# TEXAS TURNPIKE AUTHORITY

## CONTRACT No. DNT-260

# MECHANICAL, ELECTRICAL AND PLUMBING PLANS

# ADDISON AIRPORT TUNNEL

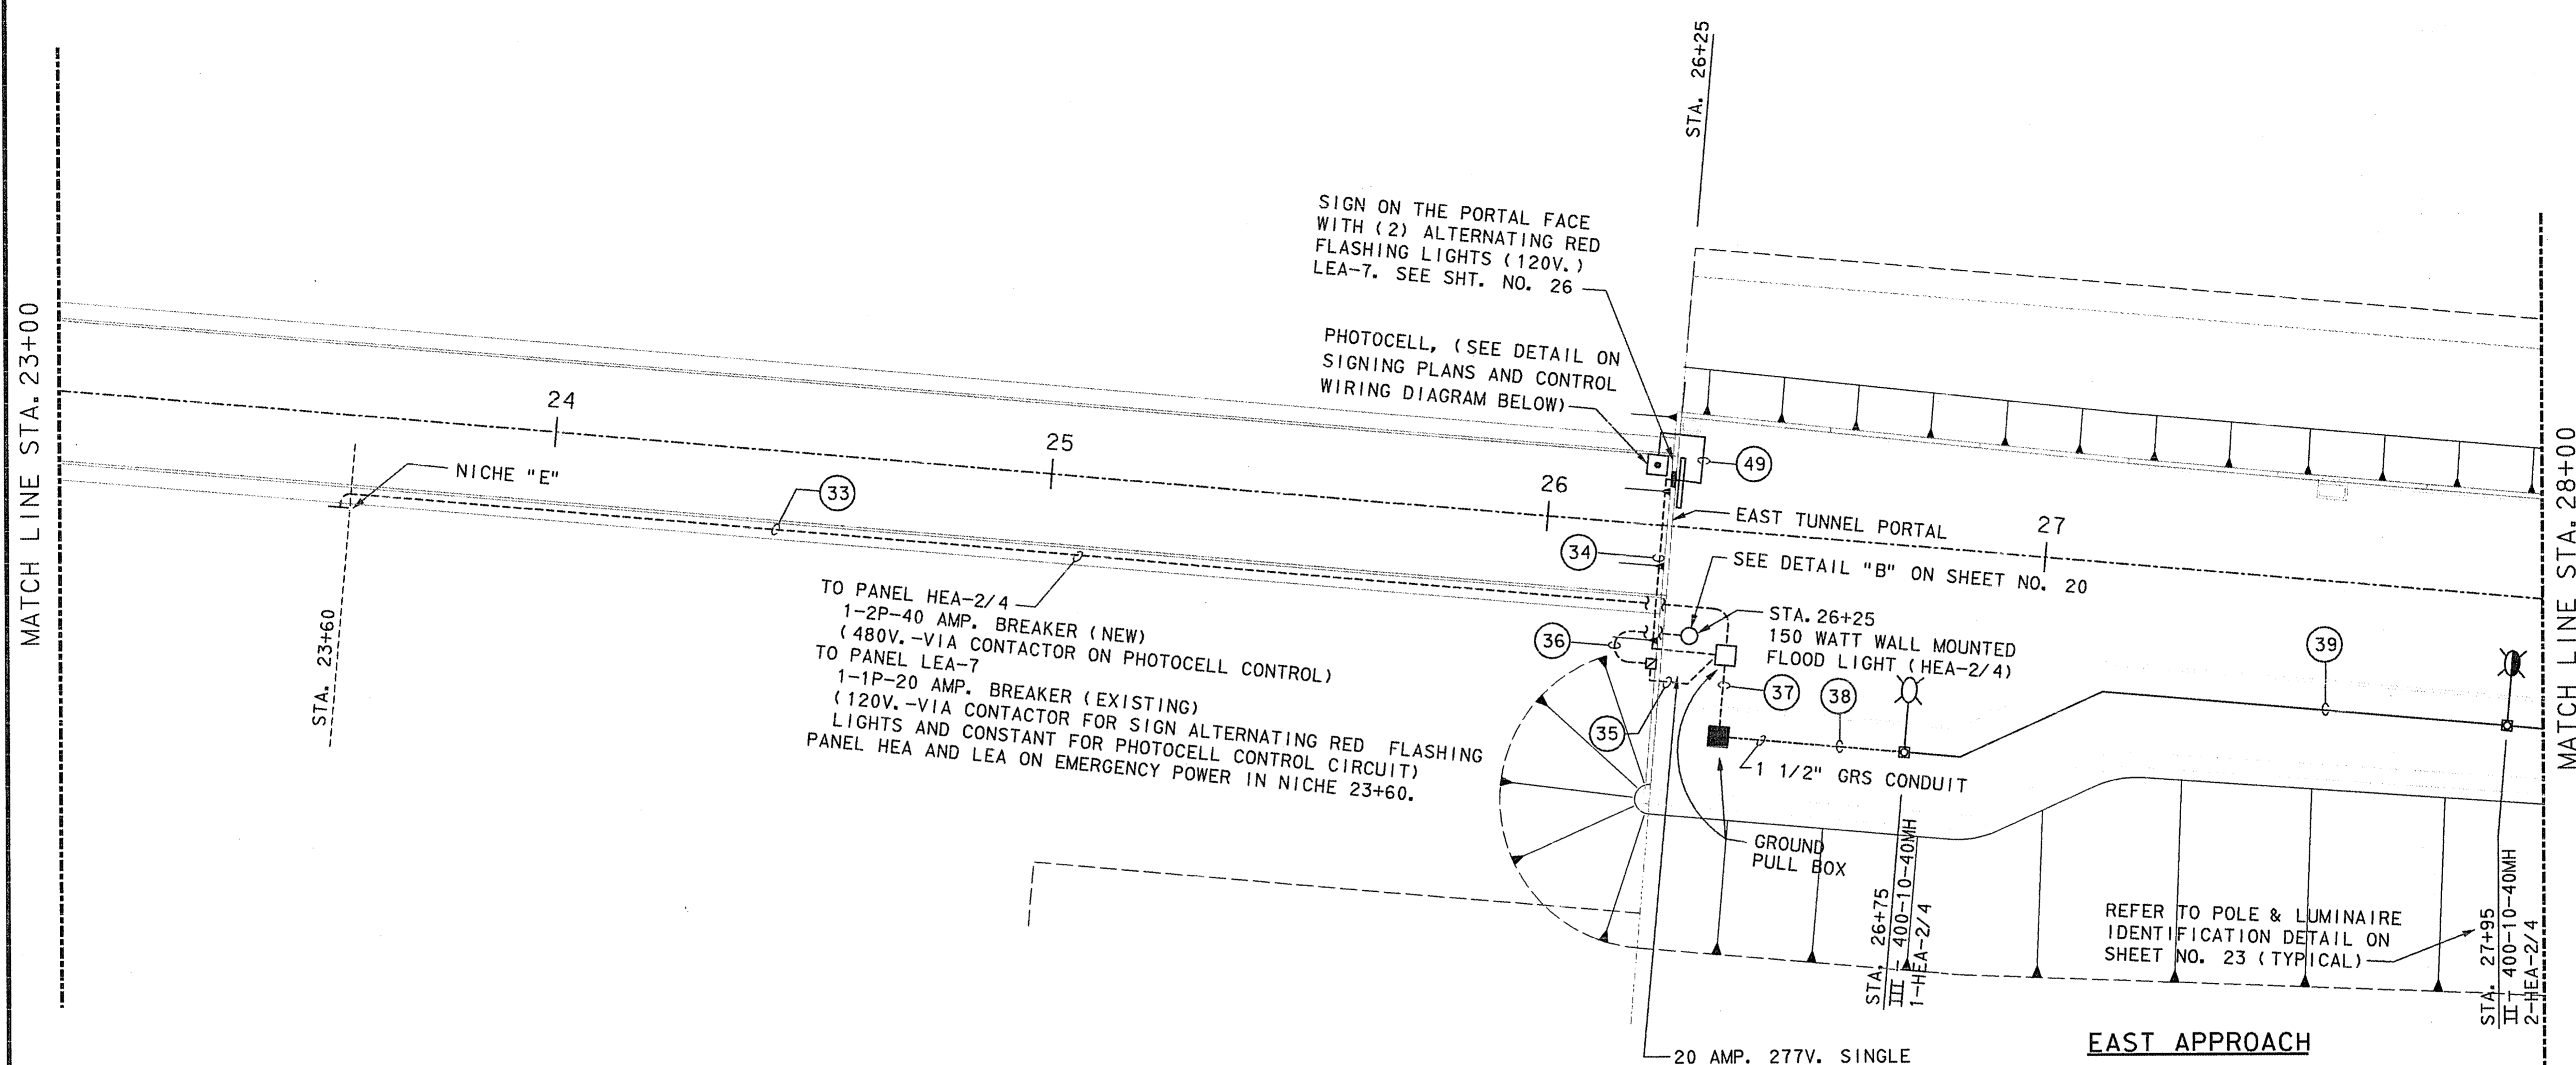
RFI # 199  
EXACT HEIGHT OF WALL  
MOUNTED ROADWAY  
ILLUMINATION SIGNS
